ADMINISTRATIVE SITE PLAN APPROVAL - FIREROCK APARTMENTS

PROJECT INFORMATION										
Project Title	Firerock Apartments			Date of Report	April 13, 2021					
File Number	PA20-048			Attachments	Site plan (Exhibit 32) and SEPA MDNS (Exhibit 35)					
Administrative Recommendation	Approve the multi-family site plan subject to the conditions of approval contained in Section 2.0.									
BACKGROUND SUMMARY										
Owner/Applicant	Ryan C. Larsen – Land Pro Group, Inc.									
Request	Administrative site plan approval in order to construct a 96-unit multi-family complex consisting of two buildings and associated site improvements.									
SEPA Status	SEPA MDNS issued March 24, 2021. The appeal period expired April 8, 2021; no appeals were file.									
Site Address	3106 87 th Avenue NE			APN(s)	00590700030201; 00590700029100 (portion of)					
Legal Description (abbreviated)	See site plan for legal description			Section	01	Township	29	Range	05	
Comprehensive Plan	MU-WR	Zoning	MU-WR	Shoreline Environment			N/A

SEPA MITIGATED DETERMINATION OF NON-SIGNIFICANCE AND TRAFFIC CONCURRENCY DETERMINATION

SP-01
 SHEET 3 OF 9

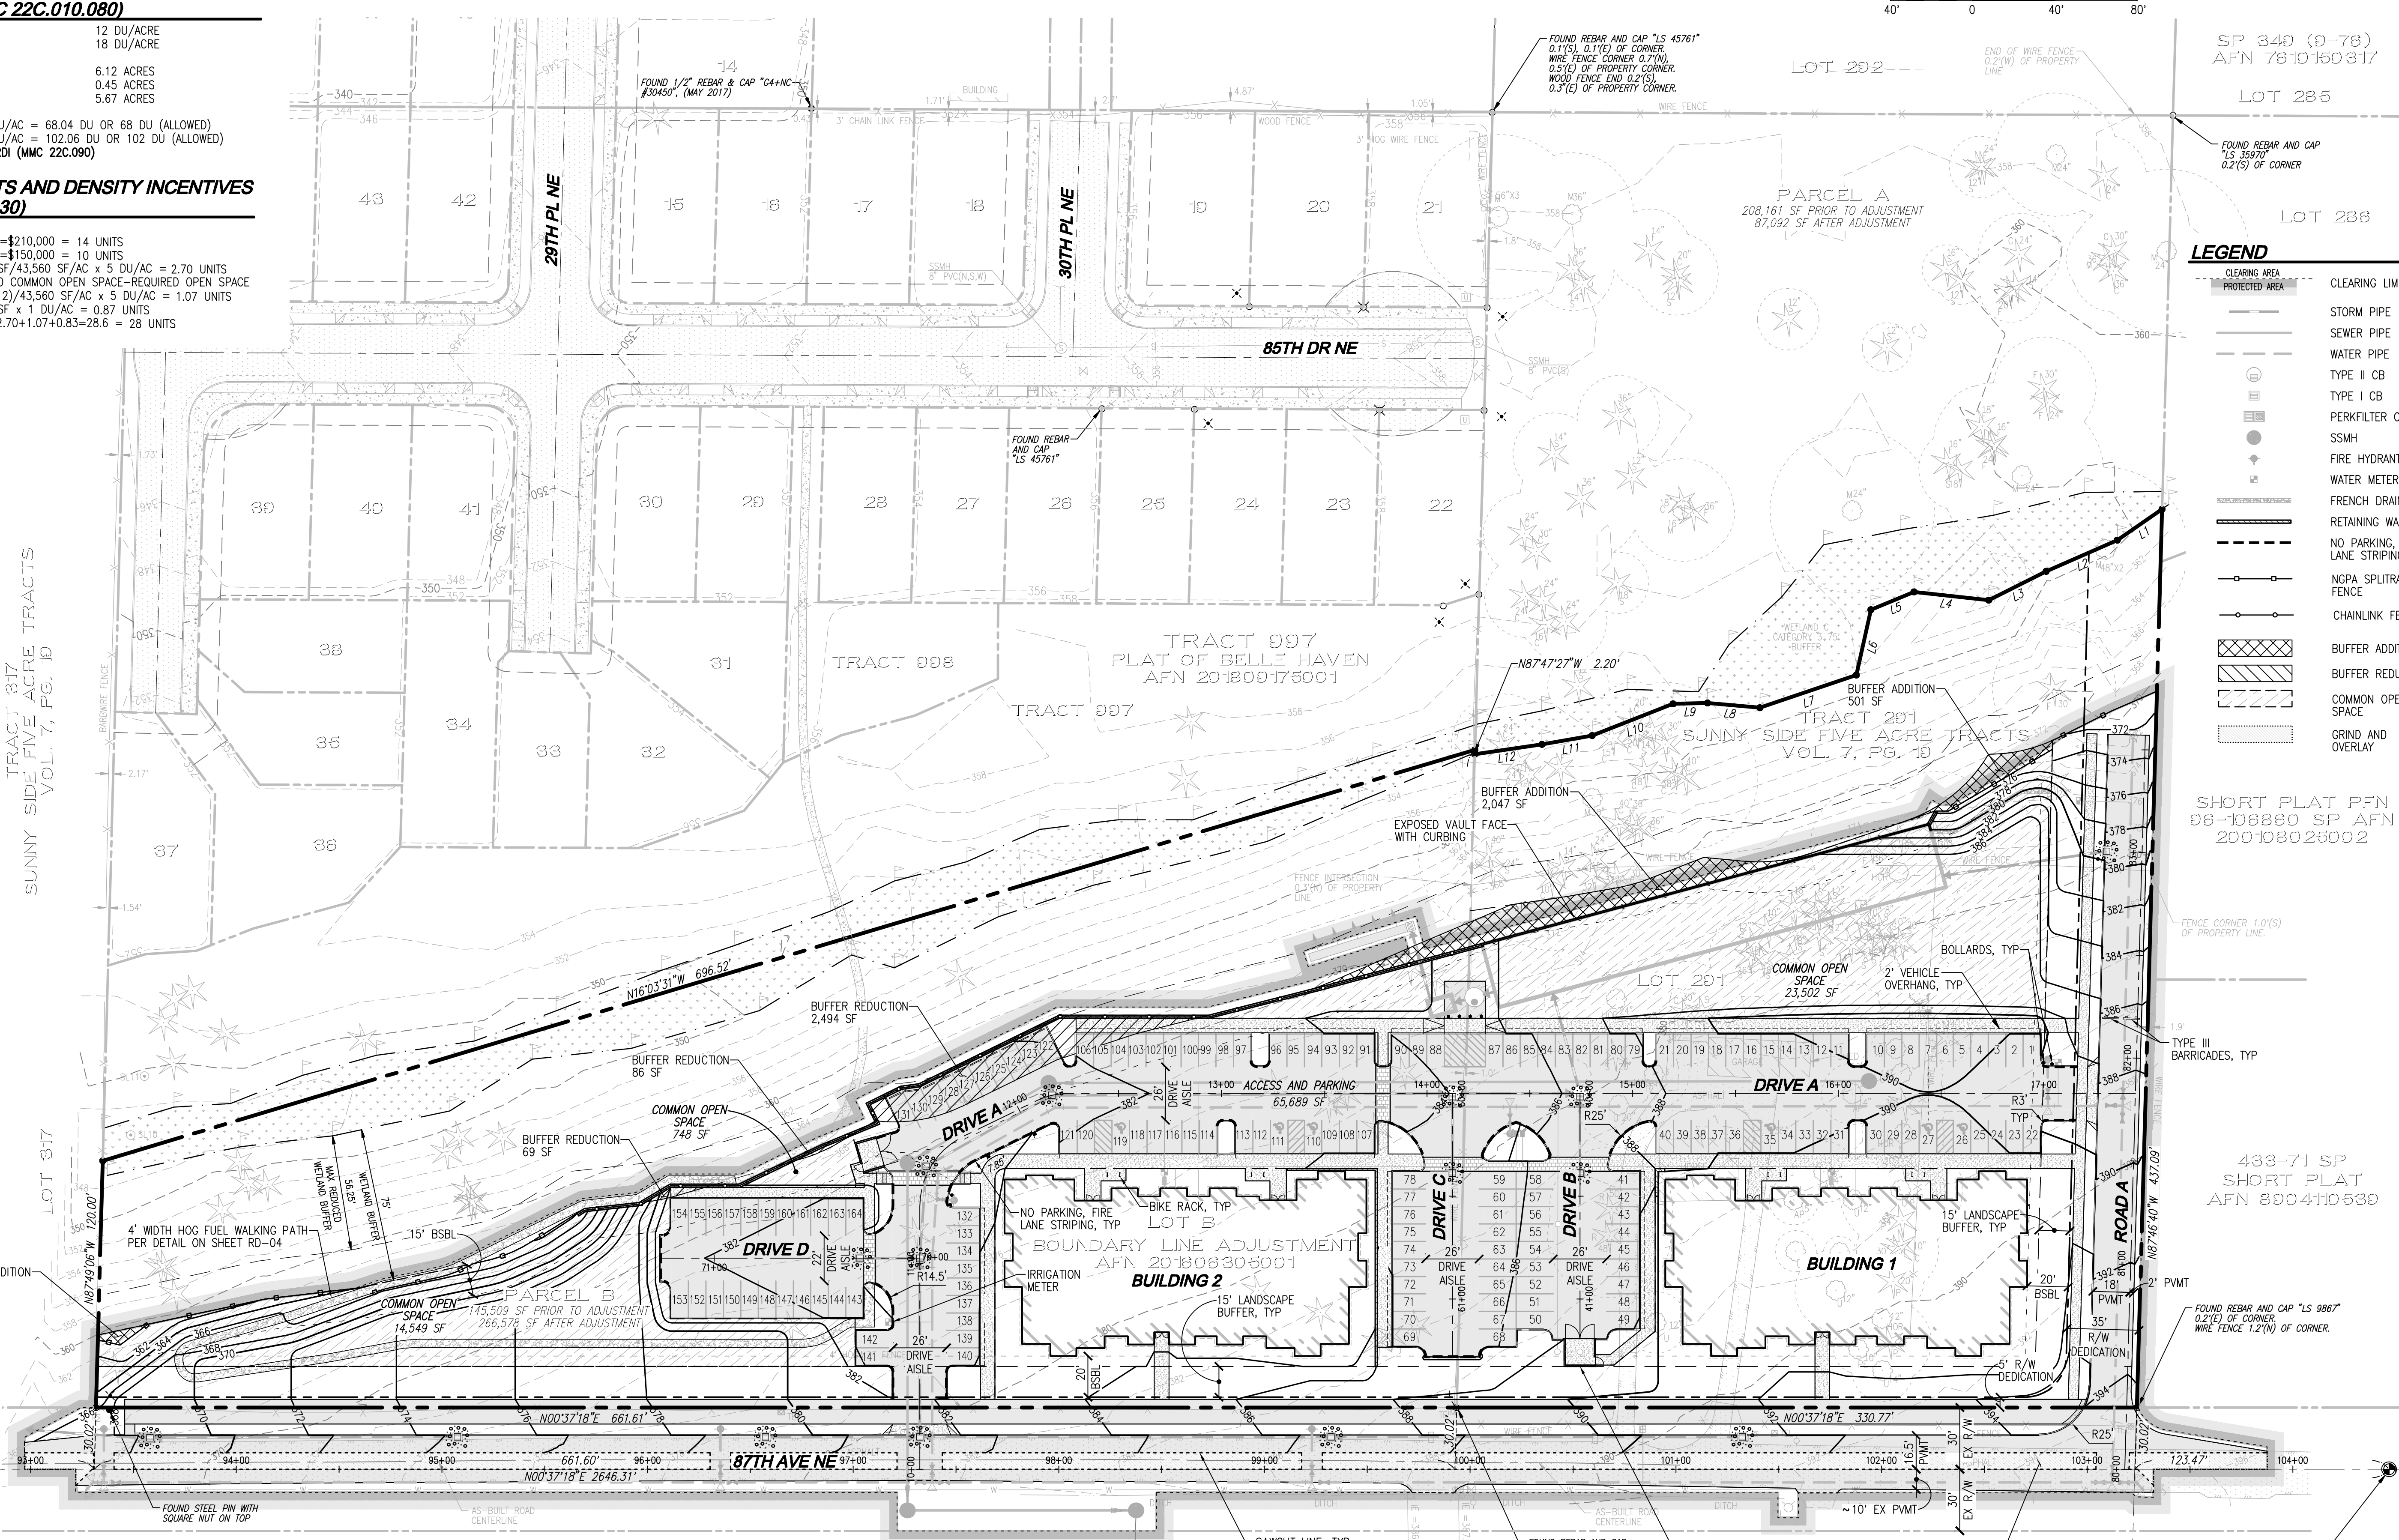
type sprinkler systems are required with one-hour separated riser rooms (riser room separated by fire resistive construction). The riser room location for both buildings is not identified on the plans. Separate fire protection system plans must be submitted to the City for Fire Marshal approval.

- Building sprinkler systems require a fire department connection (FDC) in an approved location away from the building near a fire hydrant (FDCs to be within 3 to 10 feet from hydrants). FDC locations for the buildings are not shown on the utility plan. The location of fire hydrants and FDCs requires approval on civil plans.

- Access planned appears inadequate for fire apparatus. A minimum 25 foot wide fire apparatus access is required in the immediate vicinity of any building more than 30 feet in height for ladder operations, and within 15 to 30 feet from the building along one entire side of the building. An adequate access route for fire apparatus must be in service prior to any building construction.

1. The site plan date stamped March 22, 2021 is the approved site layout (Exhibit 32); provided that, a complete pedestrian connection will be required from the south side of Building 1 to the open space area, or as otherwise approved.

Staff Response: The Fire District's comments are to be addressed during civil construction plan or building permit review as applicable.
